Vastern Park, Reading

Rebuttal Proof

Design and Townscape

LPA Application Reference: 200328/OUT

Figure 3. The parameter plan heights (above) with the 36 meters tall buildings added (below)

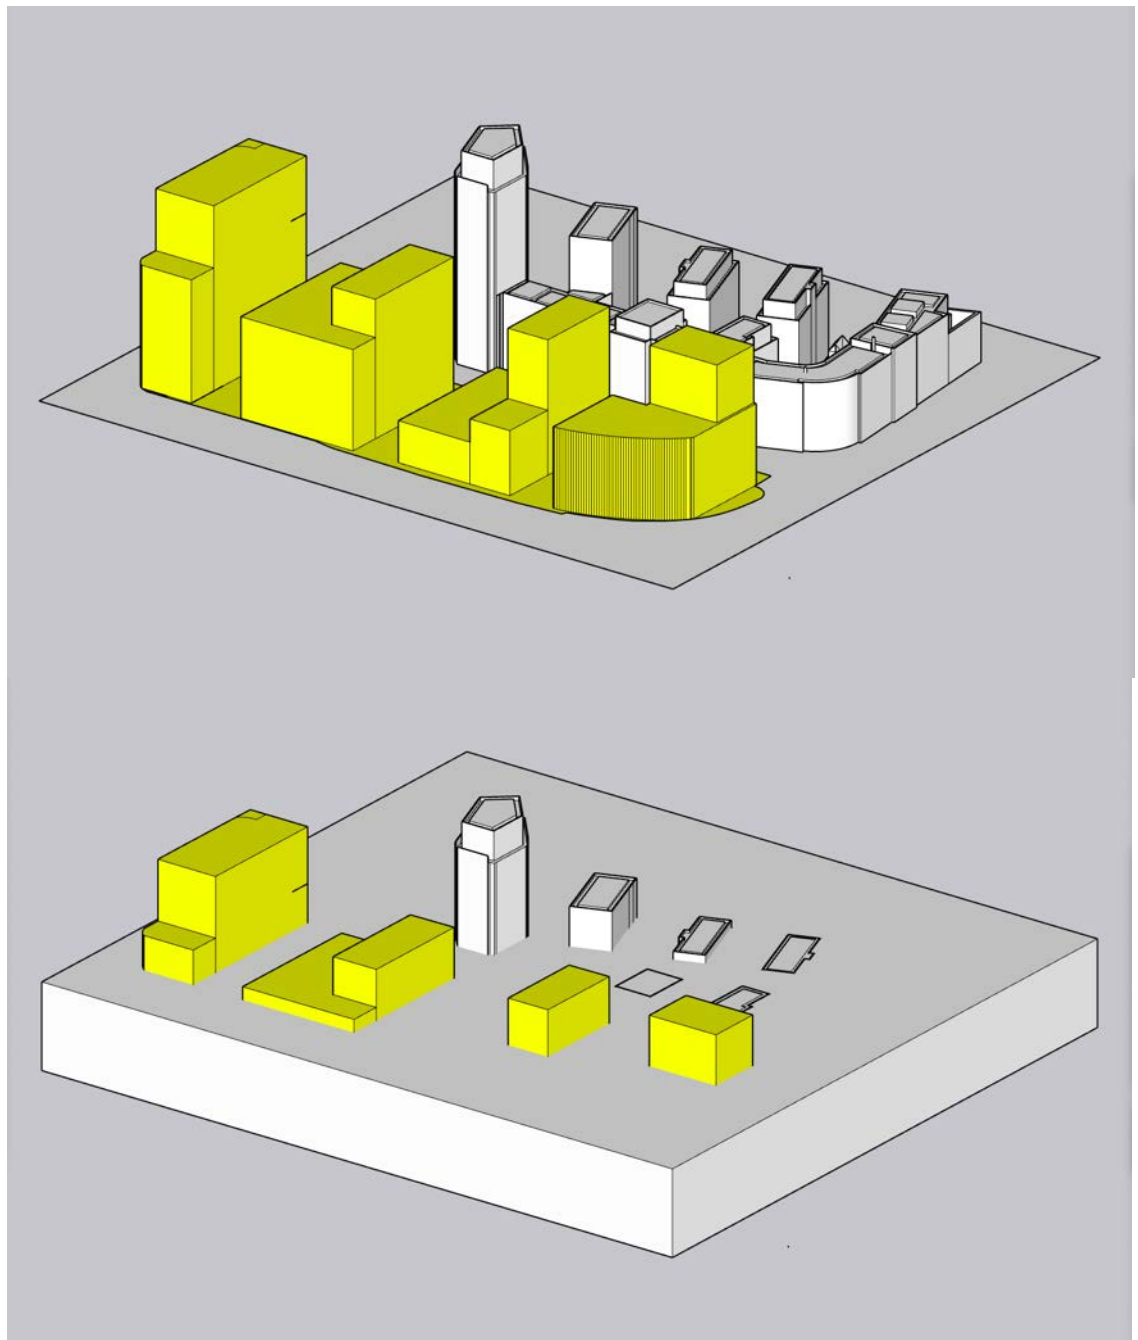
2.3.18 The figure below illustrates the Appeal Scheme parameter plan heights with the 36-meter-tall building threshold added in the second image. This shows tall buildings across the entire footprints of plots C and D rather than individual landmark buildings shown in the RSAF illustrative framework. There is also a tall building on plot A where Mr Chard acknowledges the RSAF proposes none.

Figure 4. Orthogonal view from the railway looking north towards the Appeal scheme beyond (yellow). Appeal Scheme Block A is on the left, with Block D on the right.

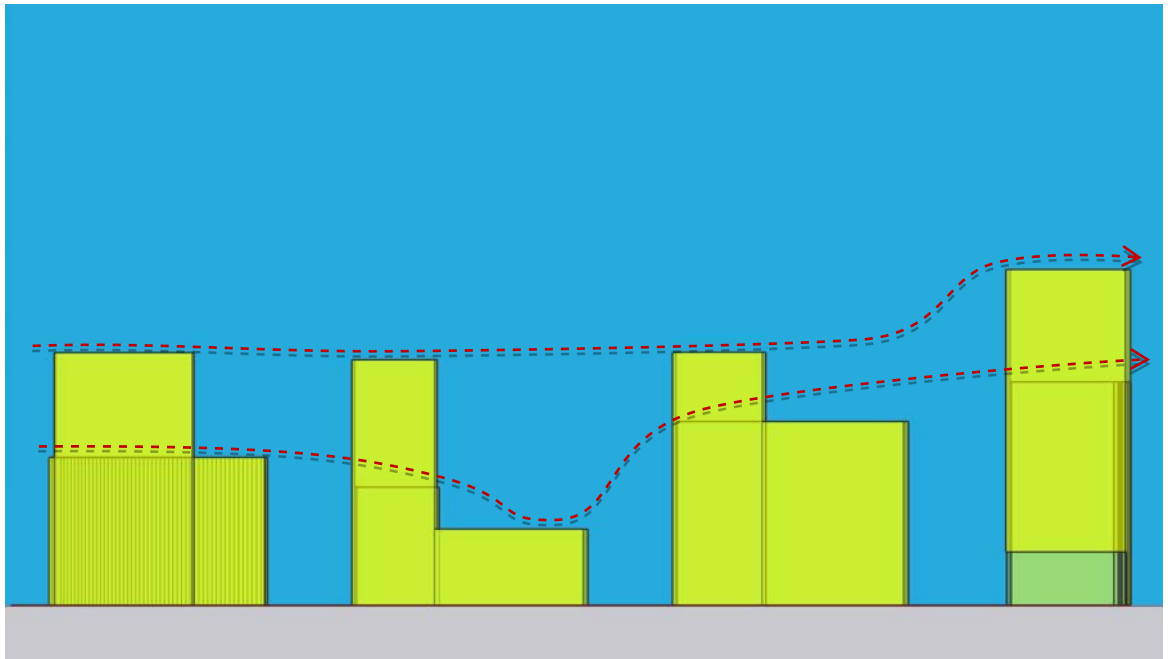
2.3.22 Mr Chard claims (7.34 page 35) my statement that the Appeal Scheme '*scatters tall buildings across the site*' (2.10.3) is unsubstantiated. The following diagrams show how tall buildings occupy every development plot, hence my statement that they are scattered across the Appeal Site.

Figure 8. Orthogonal view from the railway looking north towards the approved 80 Caversham Road Scheme (white) with the Appeal scheme beyond (yellow). Appeal Scheme Block A is on the left, with Block D on the right.

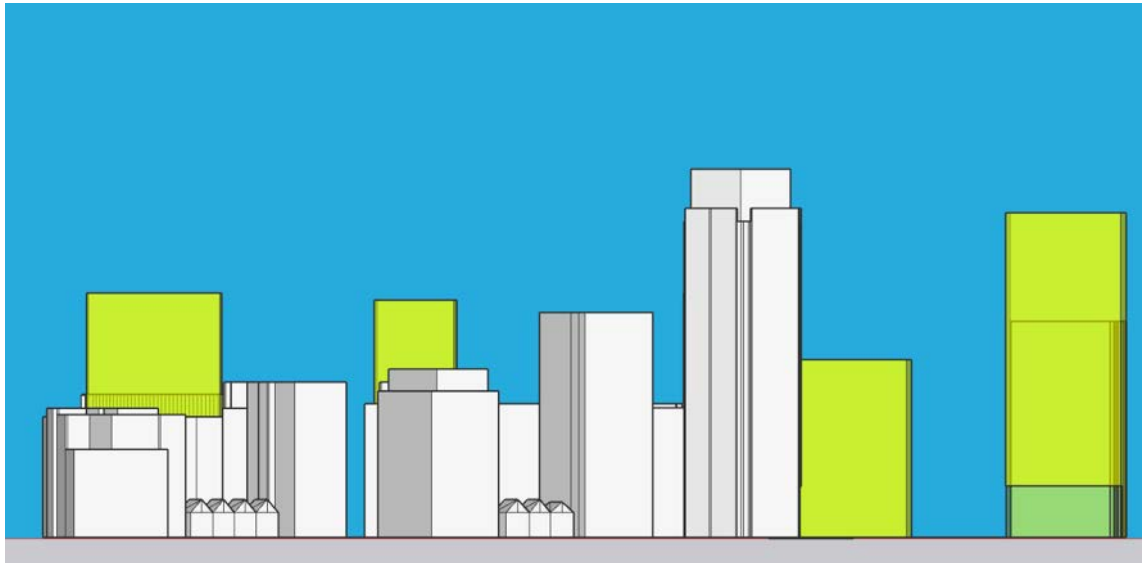
2.3.23 AVR 07 (Chard Illustrative Material Document B CDXX) now clearly shows that the appeal scheme will appear more prominent than the 80 Caversham Scheme when policy and guidance require (and the Appellant claims) the tallest buildings will be adjacent to the

Figure 11. Block D illustrative commercial scheme (DAS page 186) with parameter plan massing shown

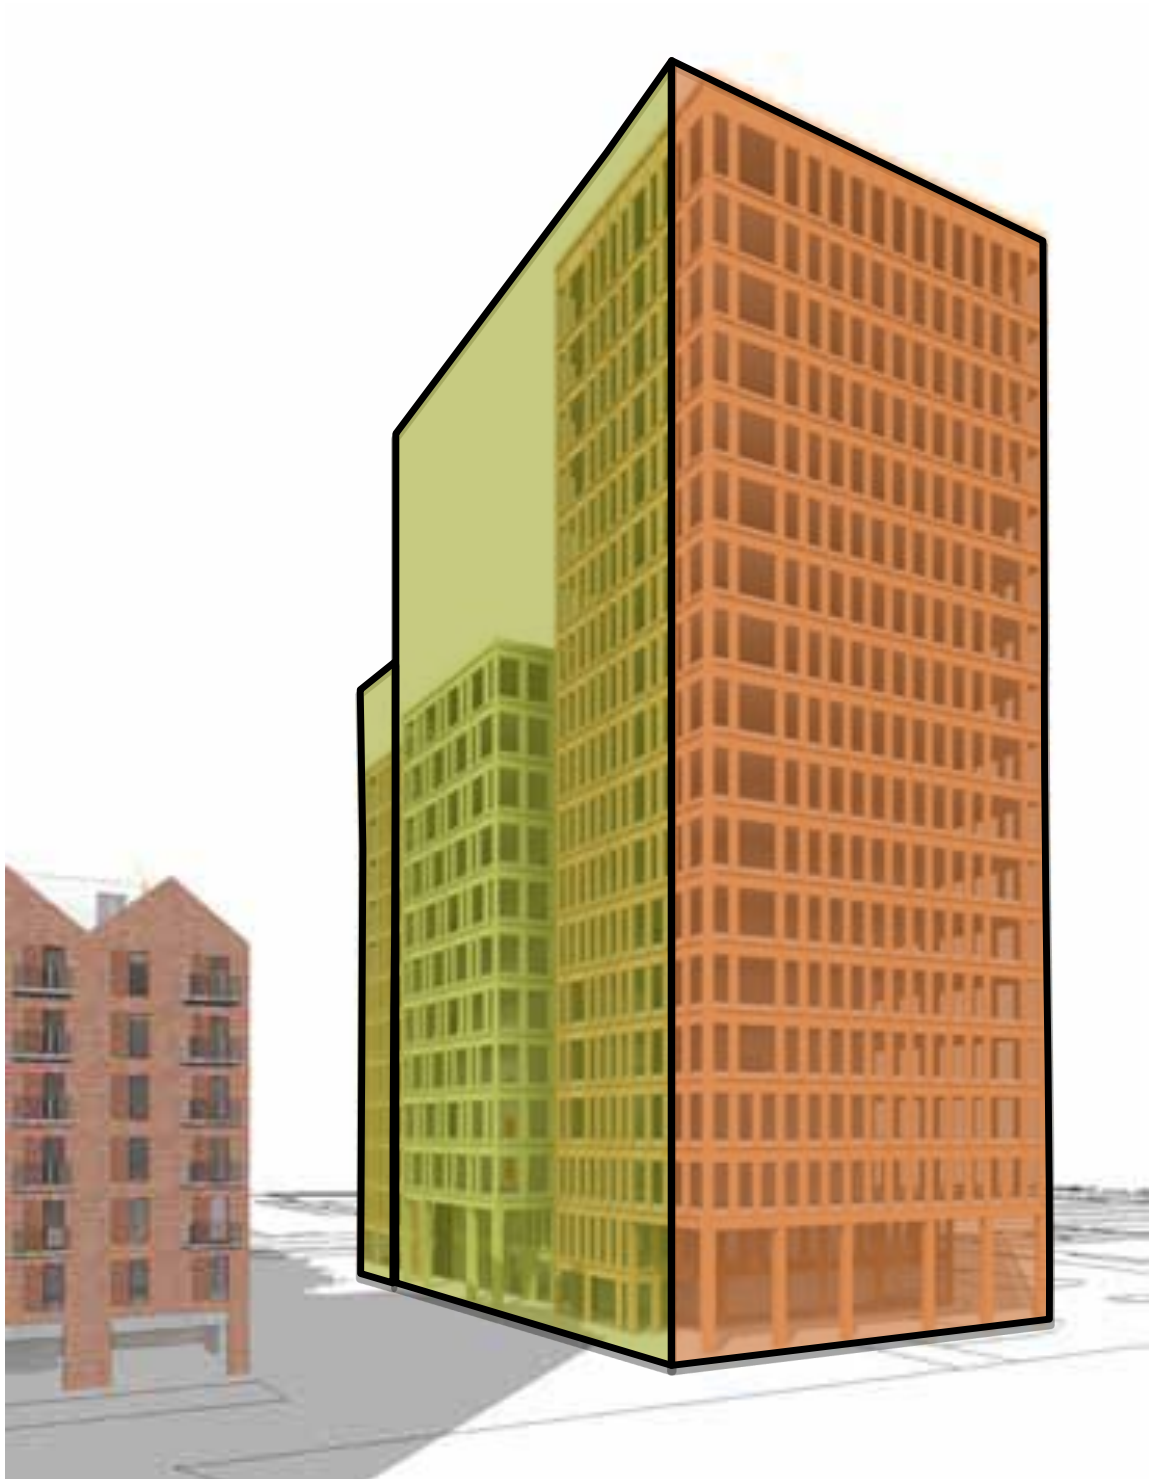
- 2.3.29 DAS page 186 illustrates this and Block D. The insets help break the mass into three volumes, reinforced by different façade treatments of each volume of the commercial towers. Notwithstanding, this modelling and façade treatment will not remedy a fundamental concern with the location, scale, and mass of tall buildings on Plot D, as indicated in the illustrative scheme. This will only be more harmful with the larger Parameter Plan volumes. The additional volume in the Parameter plans compared with the illustrative scheme will not offer the opportunity to remedy concerns with the illustrative scheme by adding or removing volumes across and between plots, because the Appellant will expect to maintain the overall quantum of development proposed in the outline application. This has already been demonstrated where The Appellant

reduced the height of Block D transferring the lost volume to Block A and thereby breaching height and massing guidance for Block A and the Scheme as a whole.

2.3.30 The illustrative scheme for Block D below shows how the Parameter Plan heights for the middle block and part of the rear block will be permitted to rise as tall as the part of the block closest to the viewer, and the front and rear block may be as wide as the middle block. This demonstrates how the Parameter Plans will act as an incentive to exceed the illustrative scheme volumes, which are already unacceptable.

Figure 12. Site Context Photo 25: View north from Station Square with Appellant's wireline above and the illustration of the commercial scheme from DAS (page 205) with the wireline superimposed below showing how the parameter plans allow a greater building mass than shown in the illustrative scheme.

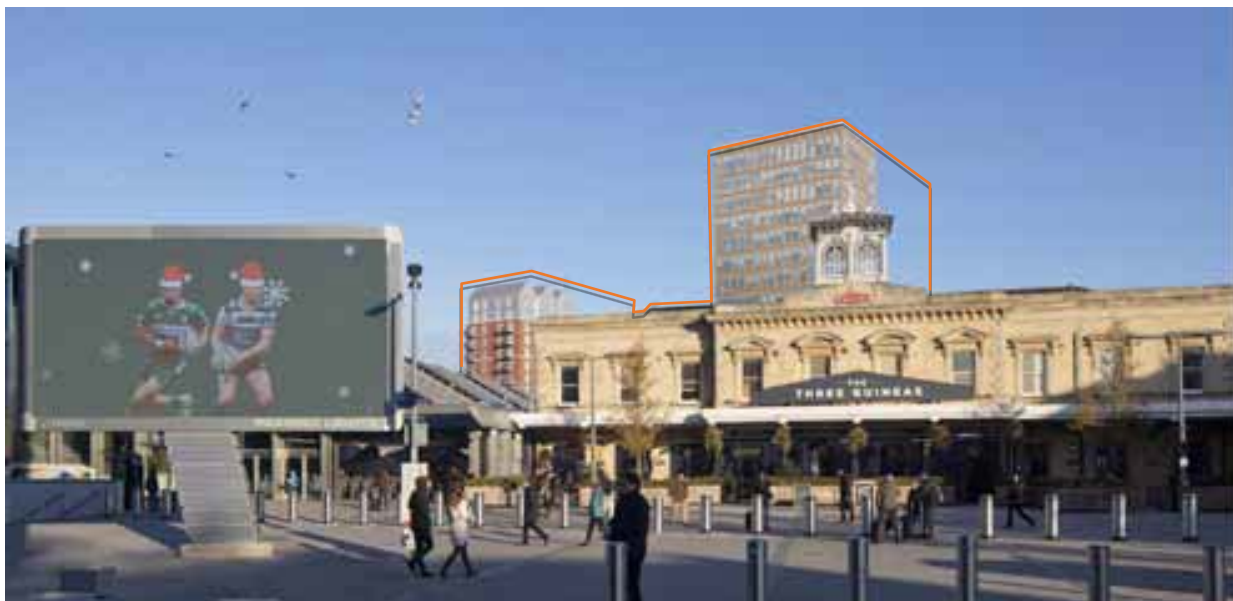
2.3.31 The DAS shows (page 186), but the design code neither encourages nor requires stepped horizontal building/plot boundary lines. This will help to break up the mass horizontal to create the impression of individual buildings but will offer decreasing value as buildings

Figure 14. Parts of Station Square South from which the tallest buildings within Plot D will appear to rise immediately behind and above the clocktower

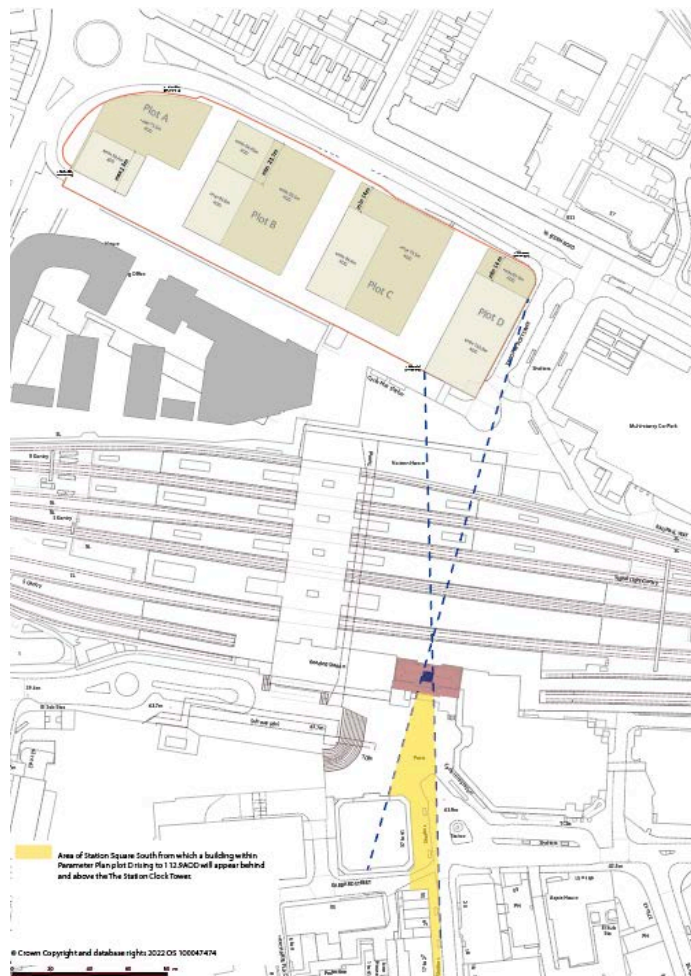
2.4.4 The figure below shows in yellow tone those parts of Station Square South from which the tallest buildings within Plot D will appear to rise immediately behind and above the clocktower, dominating views and occluding the view of the clock tower framed against the sky. The area where the view is affected is immediately in front of the station and in views from Station Road. People may move about the square and obtain different views

of the clocktower, but the most important viewpoint, the threshold of Station Road with Station Square North, will be harmed.

Figure 15. Potential reductions in Parameter building heights/positions to offset from views of the station clock tower.

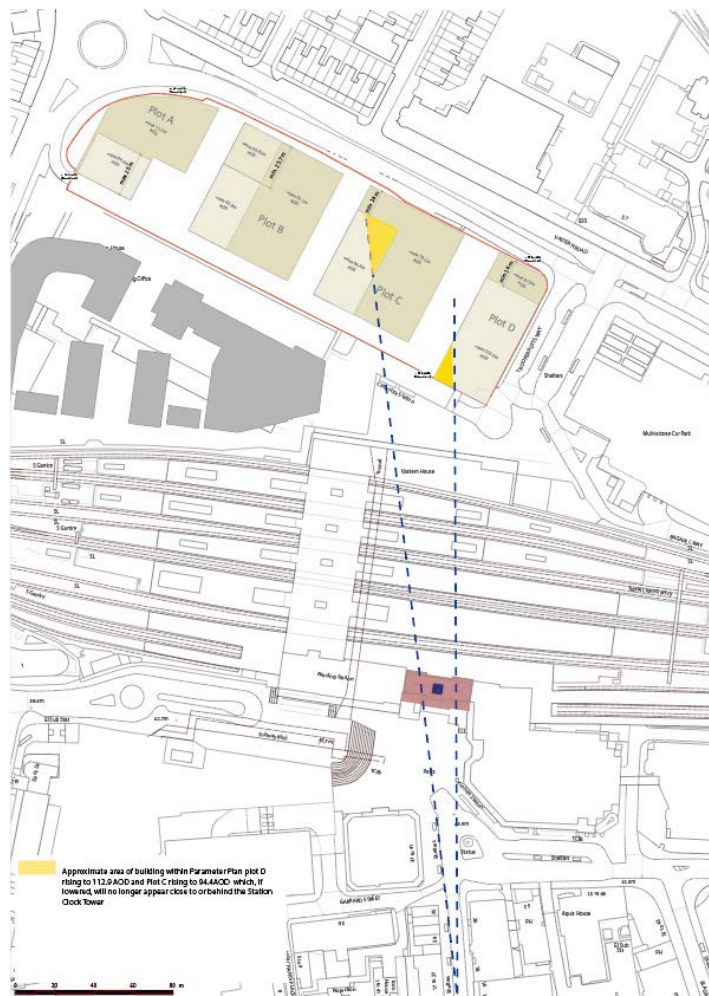
- 2.4.5 The heights and positions of tall buildings within the Appeal Scheme could be adjusted to move, reduce or completely remove the yellow shaded area- but this would mean either stepping outside Appeal Scheme Parameters, or reducing the overall development quantum, both of which are to be fixed at the outline stage.
- 2.4.6 The figure below demonstrates how adjusting the parameter plan and the appeal scheme will avoid directly affecting views of the clock tower - with development arranged on either side of the main axis, as the RSAF illustrative scheme proposes.
- 2.4.7 Mr Chard’s focus on kinetic views distracts from the need to carefully compose the specific views defined in policy. The illustrative scheme demonstrates the effect on views

is harmful. The parameter plans make this worse and are insufficiently flexible to allow adjustments to remedy this harm.

Figure 20. Examples of a strict or rigid rectilinear grid, a distorted grid, and an offset grid.

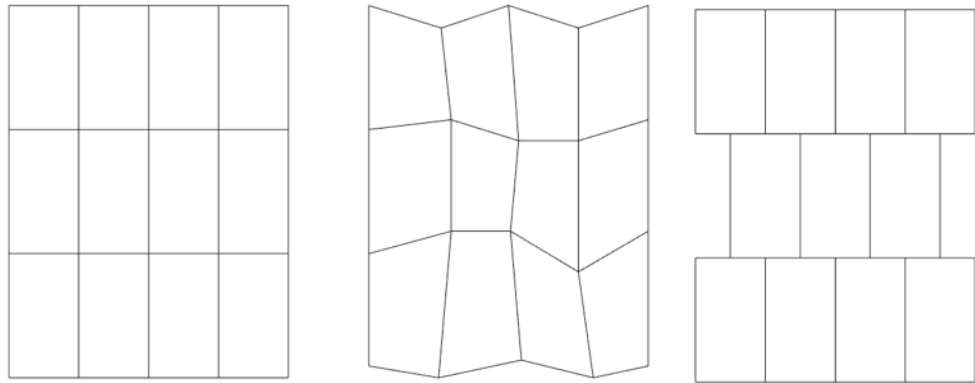
- 2.5.18 The Reading Grid forms a 'net' where streets east west and north south routes interconnect. The net may be distorted and stretched, like a fishing net, but the connections are maintained. The appeal scheme maintains and extends the grid in relation to Lynmouth and De Montford Road. However, it is an inferior 'offset grid' on the

most important north-south route. Routes in an offset grid are inherently less well connected, the path is more tortuous and legibility reduced.

Figure 26. Indicative perspective section through Vastern Road looking east.

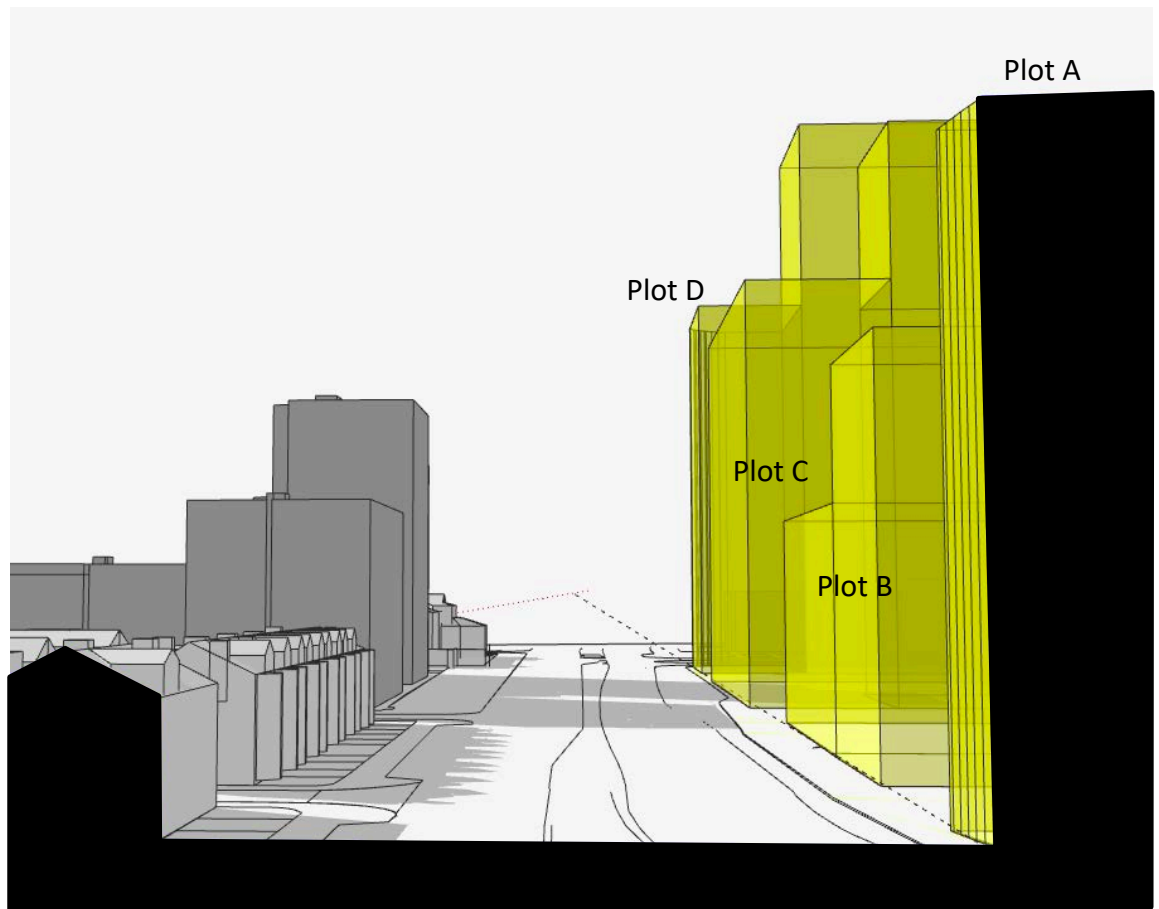
2.6.5 The figure below illustrates how the scale and setbacks are harmful and result in an unbalanced street, out of proportion with adjacent low-rise dwellings, failing to create the integrated tree-lined avenue envisaged in the policy. This results from insufficiently generous setbacks to create a threshold or setting for the new development, consistently exceeding benchmark heights, introducing tall buildings and landmarks where none are

encouraged, with buildings rising sheer from the back of narrow pavements at 26, 40 and 49 metres tall.

Figure 28. Block D oversailing

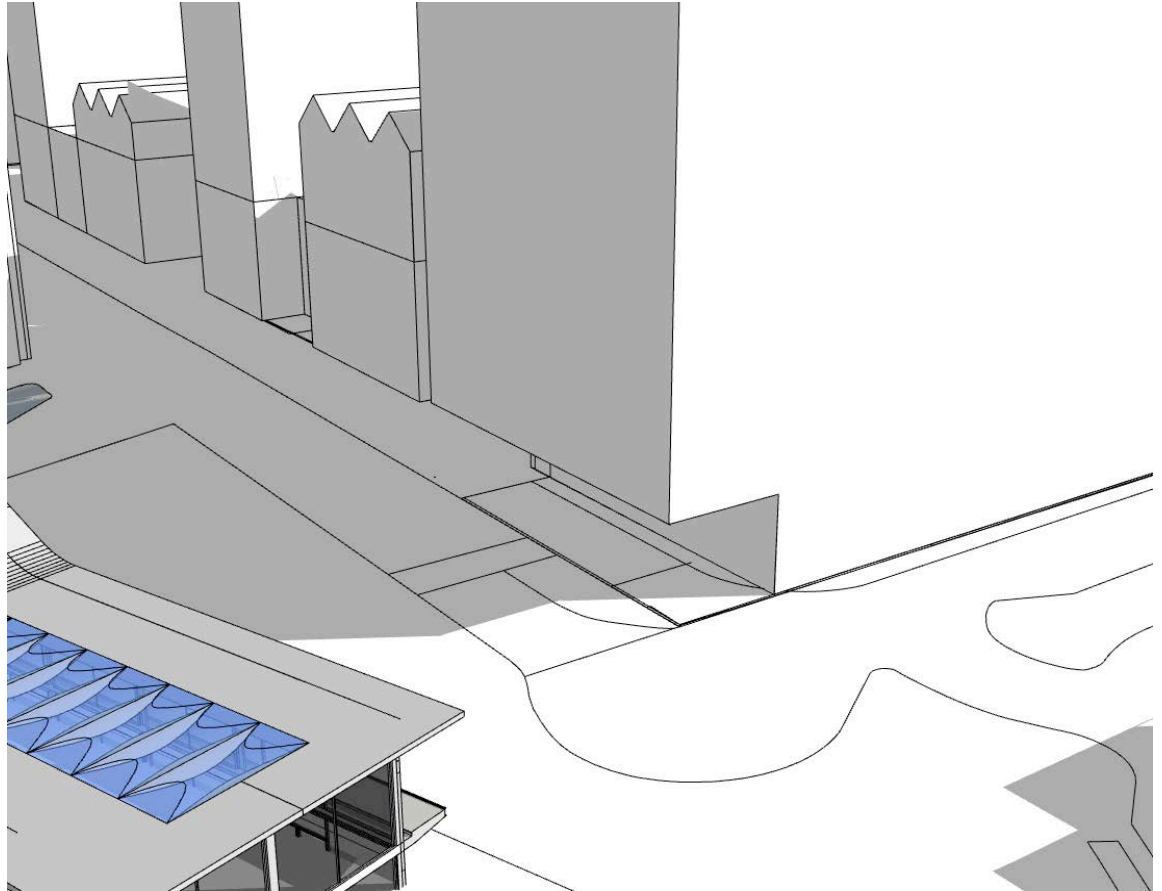
- 2.6.16 Mr Chard claims at 7.99 (page 48) that no building will over sail the public realm when it clearly will. To the south of block D, the public realm area will be over sailed from the second floor and above. The same area may also be needed to provide vehicular access.
